**JOINT DEVELOPMENT CONTROL FORUM
DARWIN GREEN ONE - BDW2 (19/1056/REM)
BDW CAMBRIDGESHIRE
22 JANUARY 2020**

INTRODUCTION

Proposed layout as submitted under application 19/1056/REM.
Massing proposal submitted under application 19/1250/S73 for Grosvenor Court incorporated.

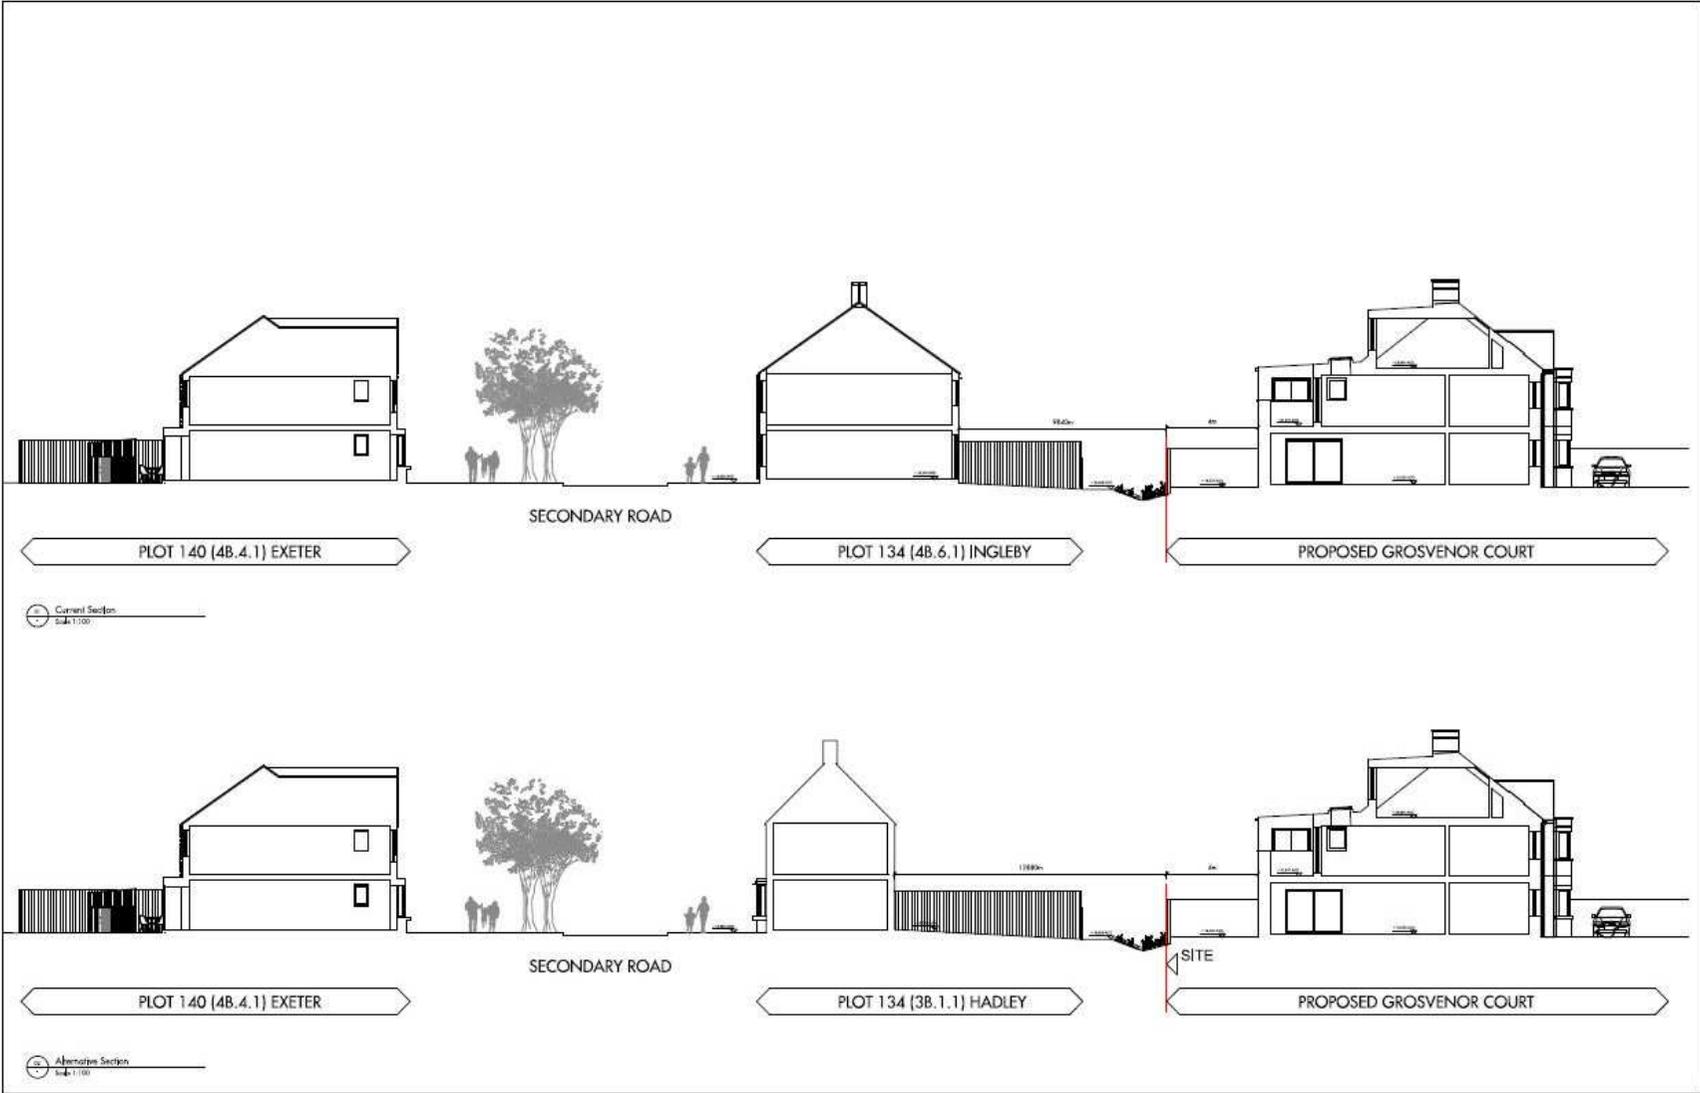
The plans submitted illustrate a historic view of the houses and flats on Woodlark Road and do not reflect the recent planning permission for the rear extensions at Grosvenor Court, or alterations and extensions to the houses in Woodlark Road over the last 10 years. The plans are therefore inaccurate. Consequently, it is not possible to ascertain accurately the impact of the new development, particularly on overlooking and daylight/sunlight issues on the existing community.

The proximity of the new development to existing perimeter buildings on Woodlark Road is too close. This is particularly relevant for 131-136 in the BDW2 plans.

The gardens behind the BDW2 houses that run parallel to Woodlark Road should be 20 metres in depth as indicated on the original pre planning drawings shown at public meetings, with an orientation that inhibits any overlooking and a size that does not impact daylight/sunlight issues.

Alternative layout in response to application 19/1250/573 for Grosvenor Court.

Drawing
**Drainage Ditch
Catchments Assessment**

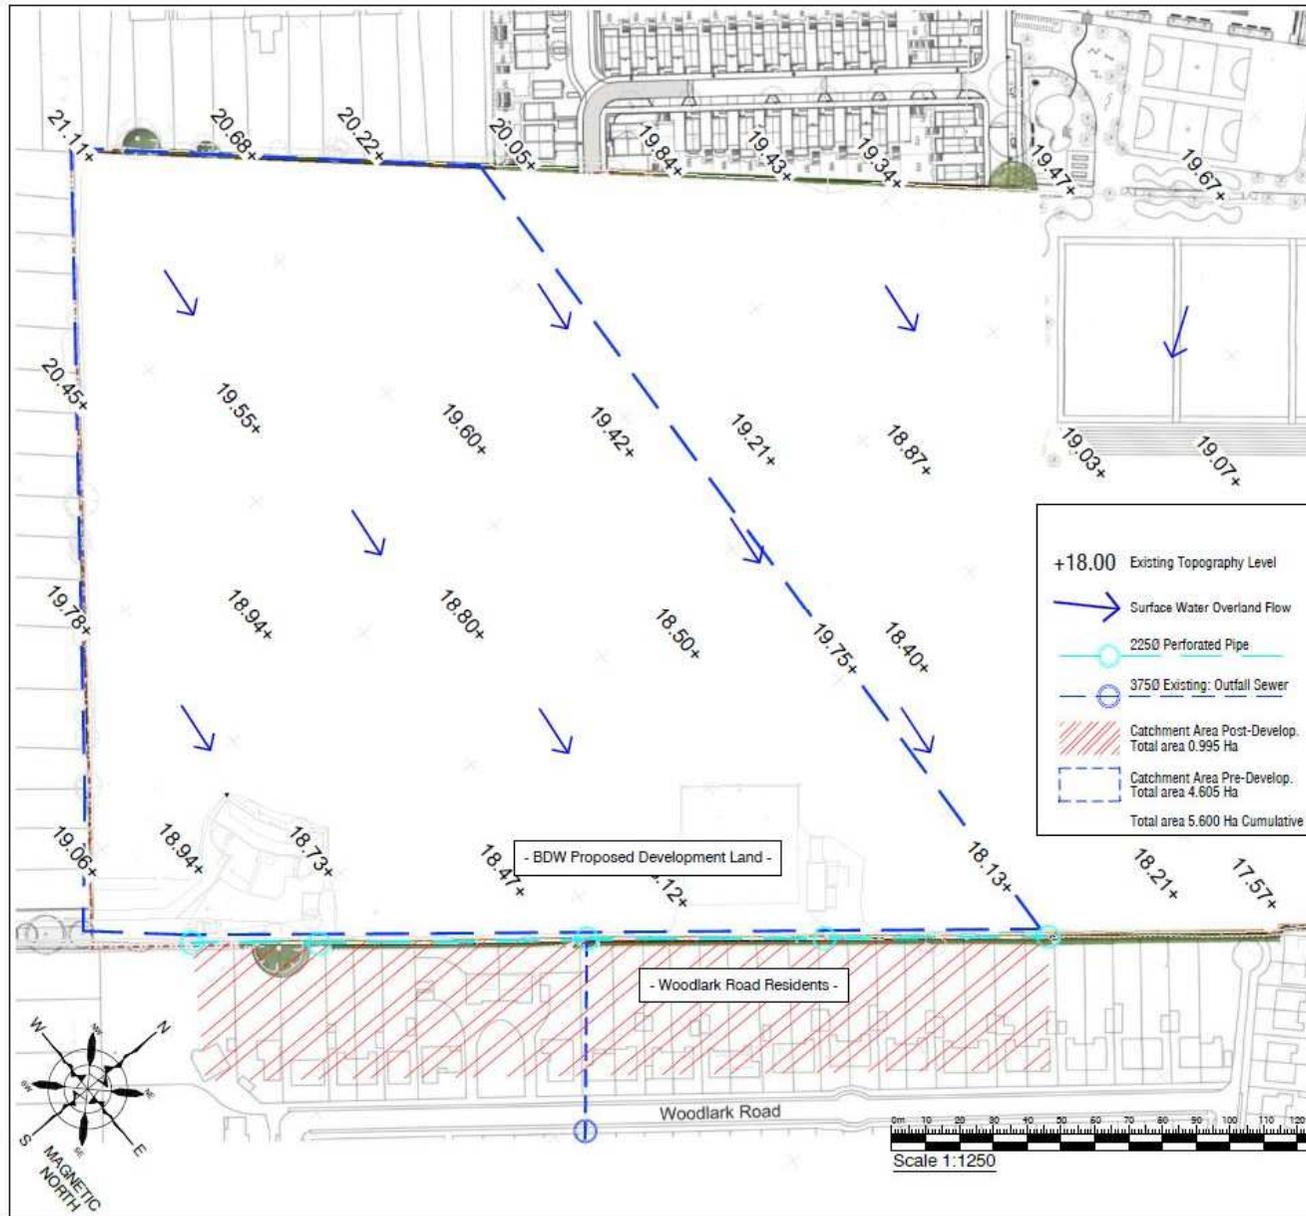
There is a real risk of flooding in the ditch which runs parallel between Darwin Green and Woodlark Road:

- a) More information needs to be provided about how the long term maintenance of the ditch will be funded. The information provided does not meet the requirements of condition 35 of the outline conditions.
- b) The security implications of the maintenance path, which runs parallel and behind the Woodlark Road, needs more consideration in its design.
- c) There is also concern that the drainage on the Darwin Green site does not have adequate capacity to allow for climate change. The proposed drainage system could be overwhelmed by heavy sustained rainfall and subsequently the overflow could cause flooding to the surrounding areas.

The drainage scheme should be reviewed to ensure it meets the required 100 year flood risks taking into account the impact of climate change. This should be carried out by an independent body. Information should also be provided on the company who will be responsible for the maintenance of the ditch along the Woodlark Road gardens.

- **Part 5a** – the ditch is not part of the strategic drainage scheme approved pursuant to condition 34 and for which the RM details would need to adhere to. The site does not discharge into the ditch. This has been investigated and the Local Authority is satisfied this is the case.
- **Part 5b-** The rear garden fences will be lowered to afford surveillance to the ditch from the rear gardens. The gates will be perpetually locked. The Local Authority is satisfied with the arrangement.
